HISTORIC AND DESIGN REVIEW COMMISSION

June 17, 2020

HDRC CASE NO: 2020-001
ADDRESS: 819 LAMAR ST
LEGAL DESCRIPTION: NCB 1368 BLK 5 LOT 19
ZONING: R-6, H
CITY COUNCIL DIST.: 2
DISTRICT: Dignowity Hill Historic District
APPLICANT: Michael Cisneros/Harmony Custom Homes
OWNER: Nickolas Markov
TYPE OF WORK: Construction of a 2-story, single-family residential structure
APPLICATION RECEIVED: May 01, 2020
60-DAY REVIEW: Not applicable due to City Council Emergency Orders
CASE MANAGER: Edward Hall

The applicant is requesting conceptual approval to construct a 2-story, single-family residential structure on the vacant lot at 819 Lamar, located within the Dignowity Hill Historic District.

SITE PLAN

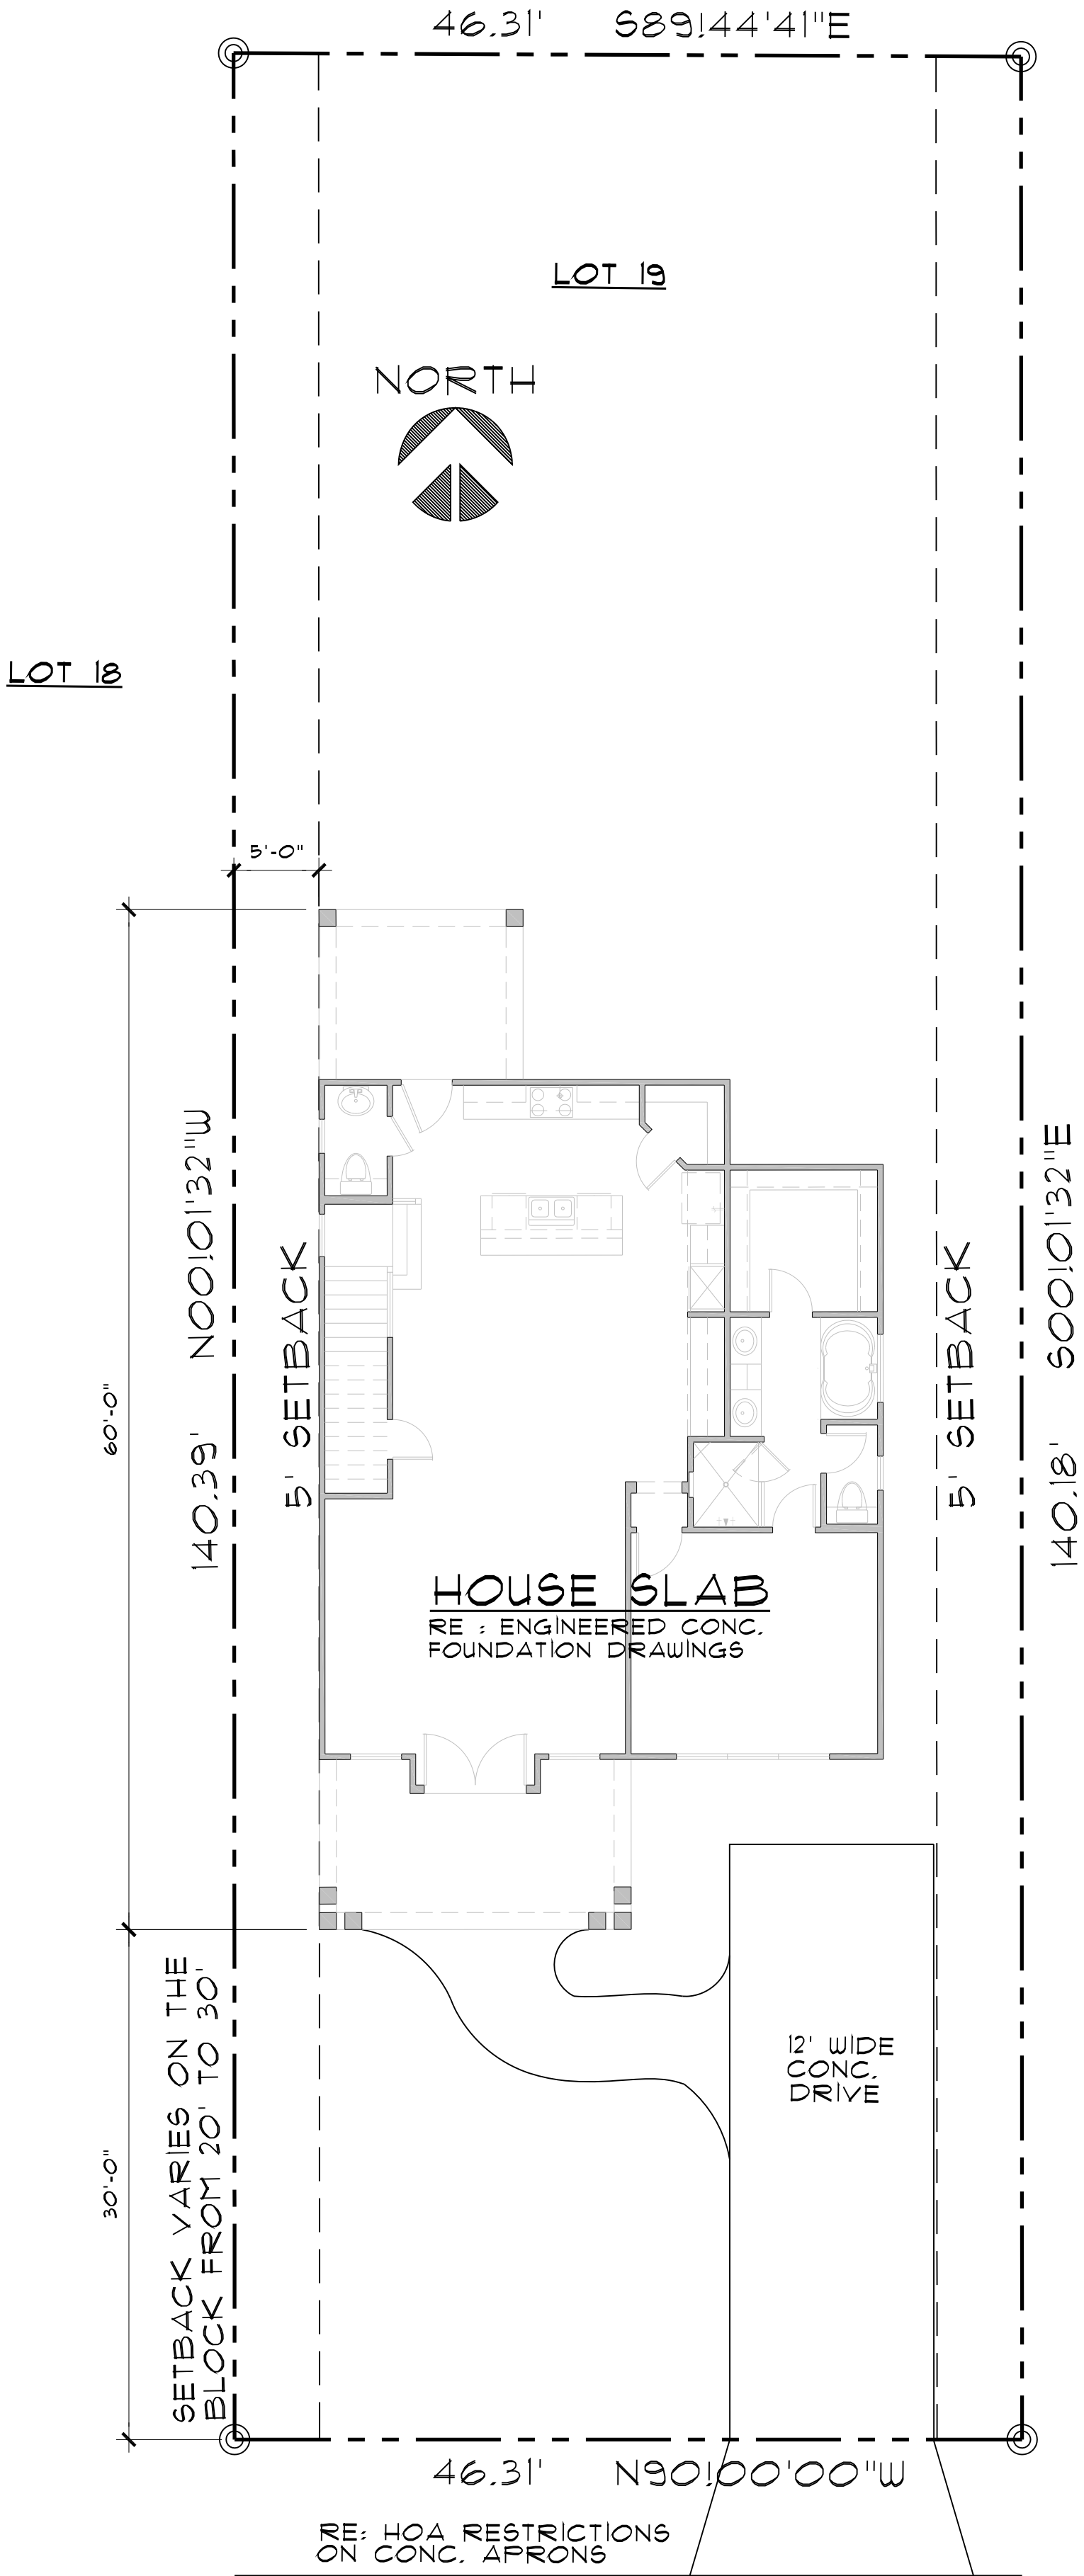
- d. SETBACKS & ORIENTATION – According to the Guidelines for New Construction, the front facades of new buildings are to align with front facades of adjacent buildings where a consistent setback has been established along the street frontage. Additionally, the orientation of new construction should be consistent with the historic examples found on the block. The applicant has noted a setback of thirty (30) feet from the front porch to the property line; however, the applicant has not noted how the correlates to historic structures found on the block. Staff finds that the applicant should provide documentation noting that the proposed new construction will feature a setback that is equal to or greater than those found historically on the block.

- n. DRIVEWAY – The applicant has proposed a site configuration that will result in the proposed driveway terminating at the front façade of the proposed new construction. The Guidelines for Site Elements 7.A. notes that front yard parking should not be added into the front yard setbacks. Staff finds the proposed site configuration to be inconsistent with the Guidelines.

- o. FRONT WALKWAY – The applicant has proposed a front walkway that leads to the on site driveway, rather than leading to the sidewalk at the right of way, as is the historic pattern within the district. The Guidelines for Site Elements note that front yard sidewalks should appear similar to those found historically within the district in regards to their materials, width, alignment and configuration. Staff finds that the proposed front yard walkway is inconsistent with the Guidelines, and that a simply, concrete walkway that matches those found historically within the district be installed.

- i. That the applicant provide documentation noting that the proposed new construction will feature a setback that is equal to or greater than those found historically on the block, as noted in finding d.

1 BUILDING SECTION

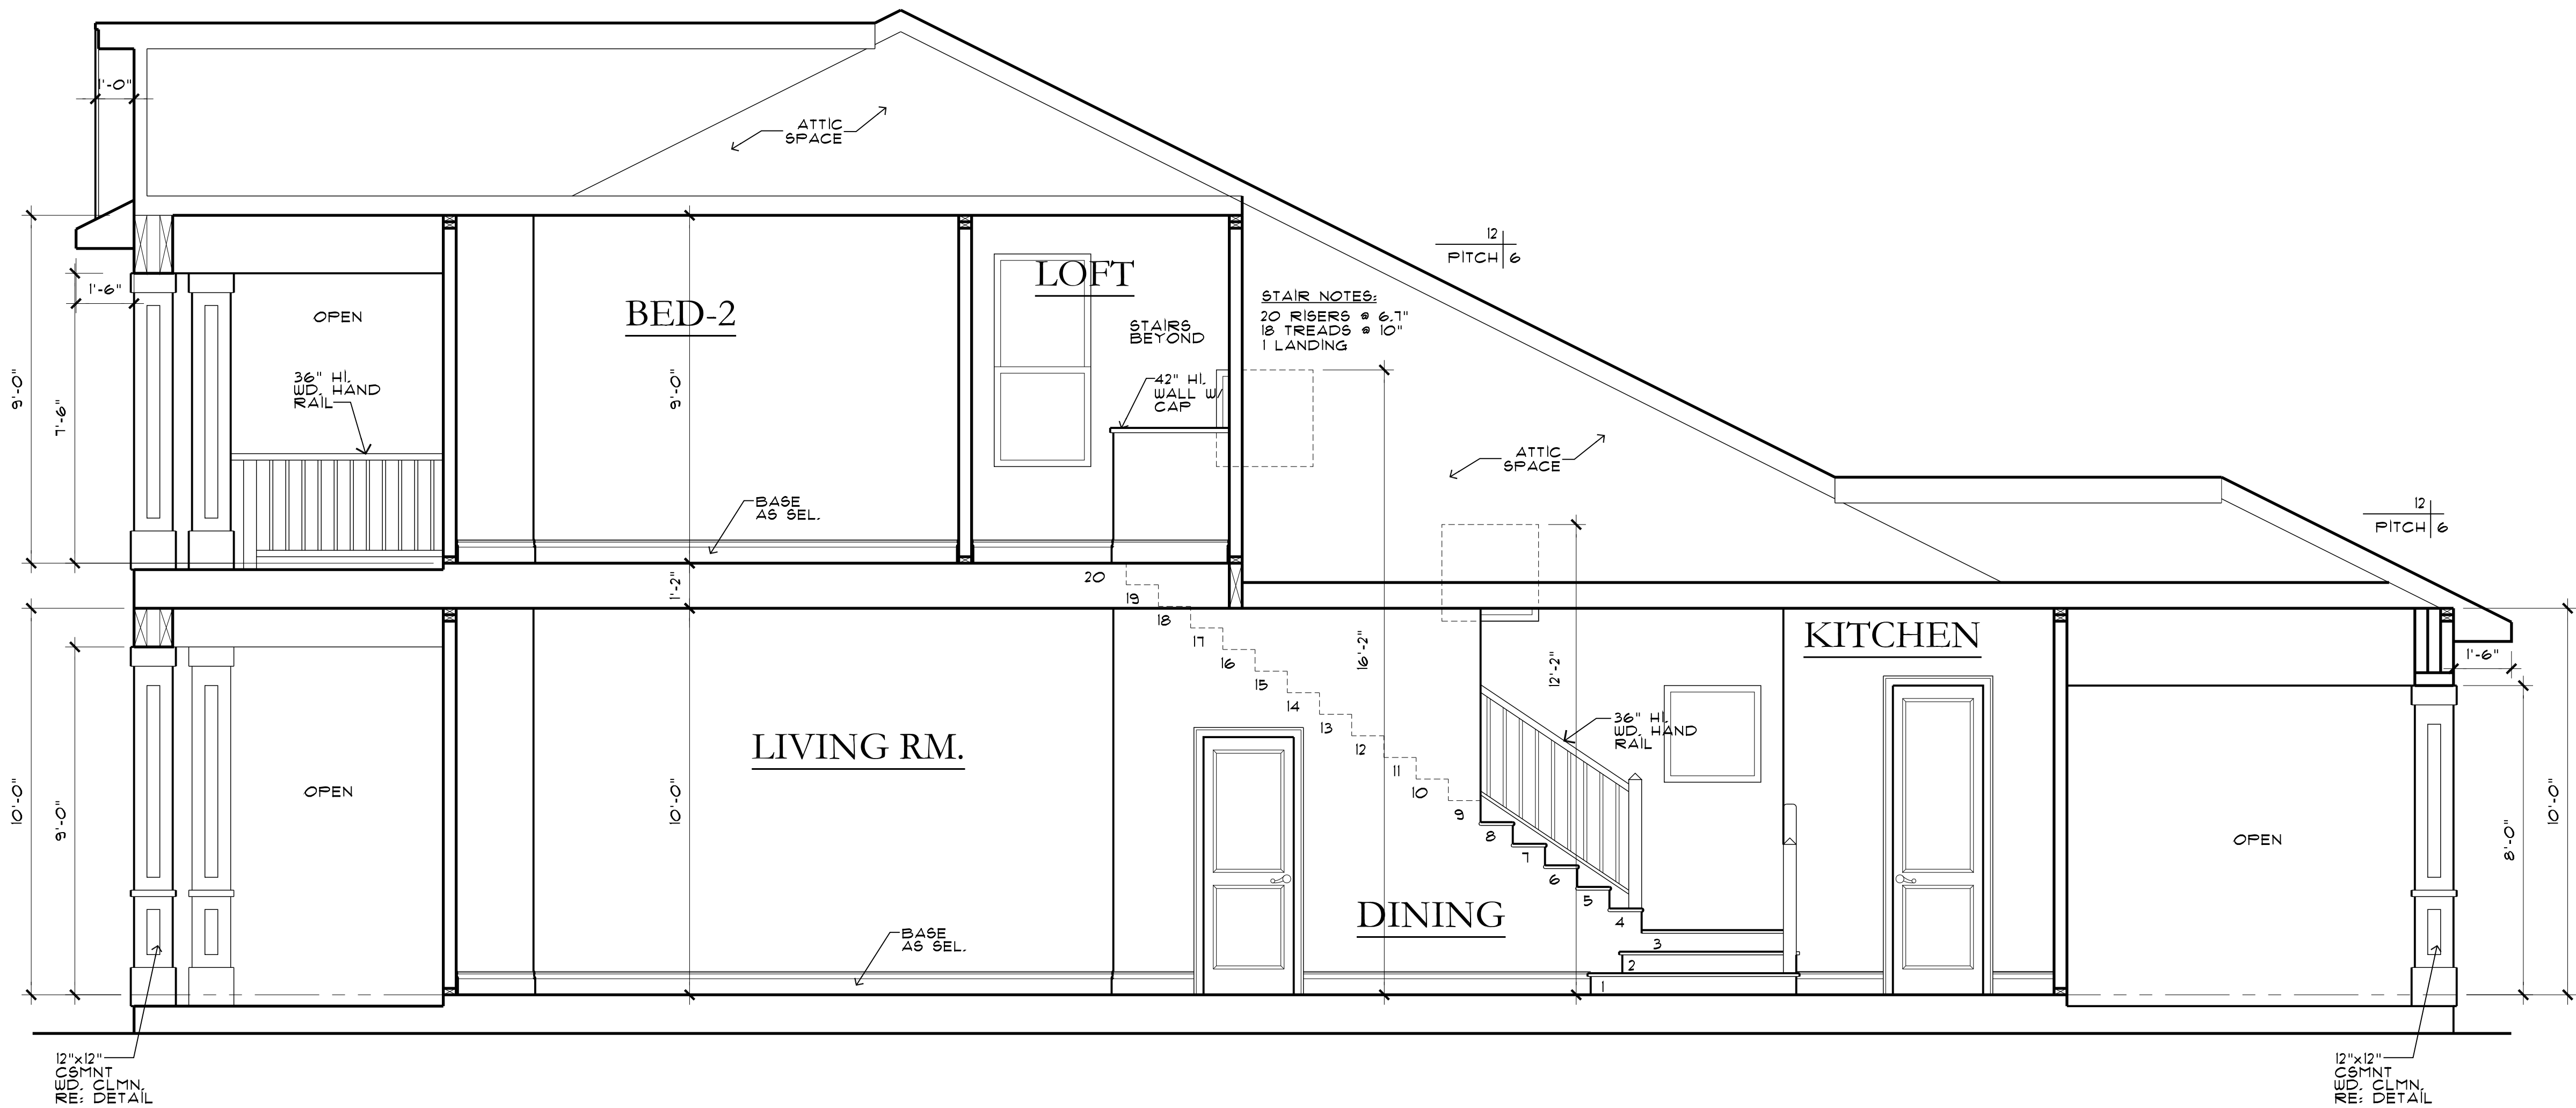
- f. SCALE & MASS – Per the Guidelines for New Construction 2.A.i., a height and massing similar to historic structures in the vicinity of the proposed new construction should be used. In residential districts, the height and scale of new construction should not exceed that of the majority of historic buildings by more than one-story. As noted in finding b, this block of Lamar predominantly features 1-story historic structures, and one 2-story historic structure. The applicant has proposed an overall height of approximately twenty-six (26) feet. Generally, staff finds the proposed height of two stories to be appropriate; however, staff finds that the structure features a massing towards the rear that is atypical of historic structures found within the district. Staff finds that the applicant should modify the proposed massing, specifically that which relate to the rear roof's profile and massing.

- h. ROOF FORM – The applicant has proposed a roof form that consists of both front and side gabled roofs. Generally, staff finds these forms to be appropriate; however, the front facing gable should feature a ridge height that is consistent with the side facing gable, as found historically within the district. As noted in finding f, the proposed massing of the roof form toward the rear of the proposed new construction is inconsistent with those found historically within the district. The rear roof form should feature a traditional roof form, such as a gable or hip.

- ii. That the applicant modify the proposed massing, specifically that which relate to the rear roof's profile and massing as noted in finding f and h.

TYP. COLUMN DET.

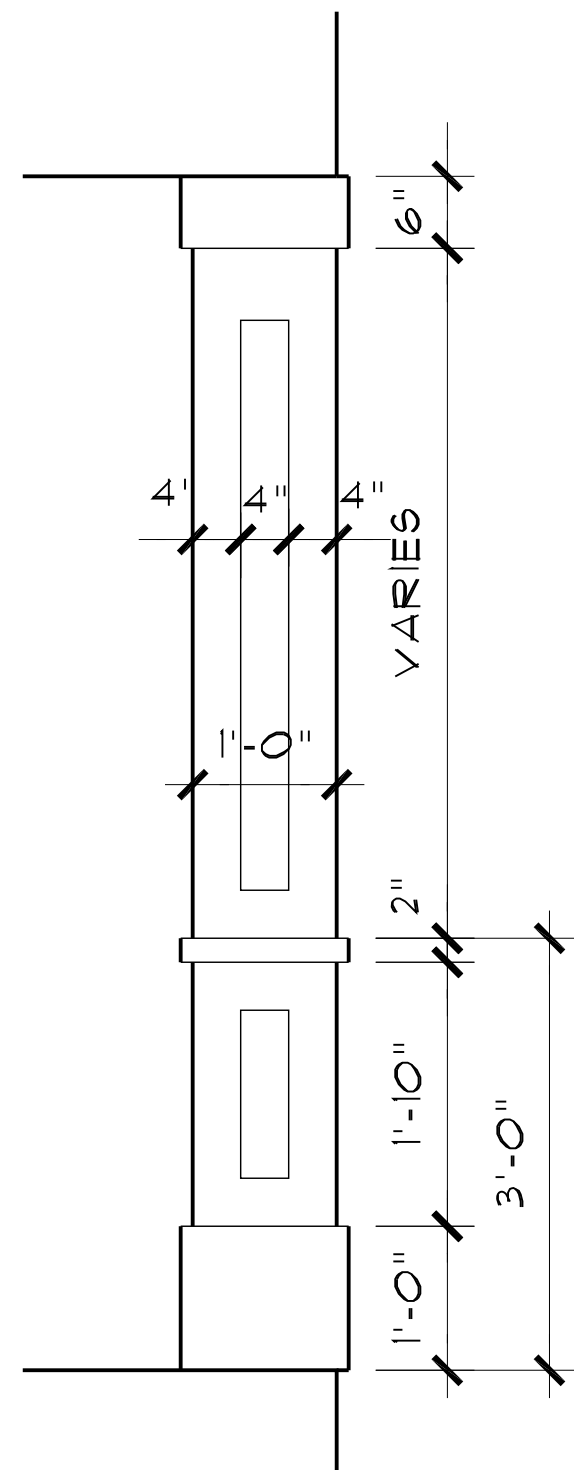
- m. ARCHITECTURAL DETAILS – As noted in the above findings, staff finds that roof forms and fenestration profiles should be modified to be consistent with those found historically within the district. Additionally, staff finds that porch and column configuration that is consistent with those found historically in the district (specifically related to double height porches) should be used. The applicant has proposed column profiles and spacing that is atypical for historic double height porches found historically within the district.

- vi. That porch and column configuration that is consistent with those found historically in the district (specifically related to double height porches) be used, as noted in finding m.

TYP. WDW TRIM DET.

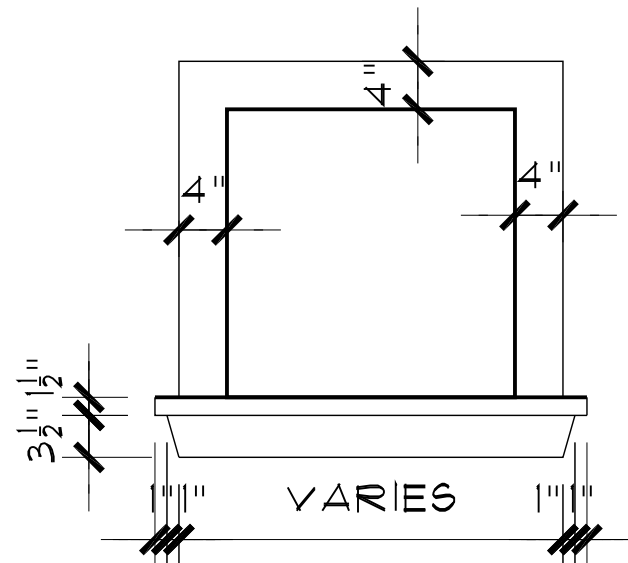
- k. WINDOW MATERIALS – As noted in finding j, the applicant has proposed vinyl windows. Many of the windows that the applicant has proposed feature sizes and profiles that are inconsistent with those found historically within the district. Additionally, staff finds that ganged windows should be separated by a mullion

of at least six (6) inches in width, rather than feature one single unit with two windows. Staff finds that staff's standard specifications for windows in new construction should be followed, which are noted in the applicable citations. The proposed windows do not meet these specifications.

- iv. That the applicant install windows that are consistent with staff's standards for windows in new construction, referenced in the applicable citations, as noted in finding k.
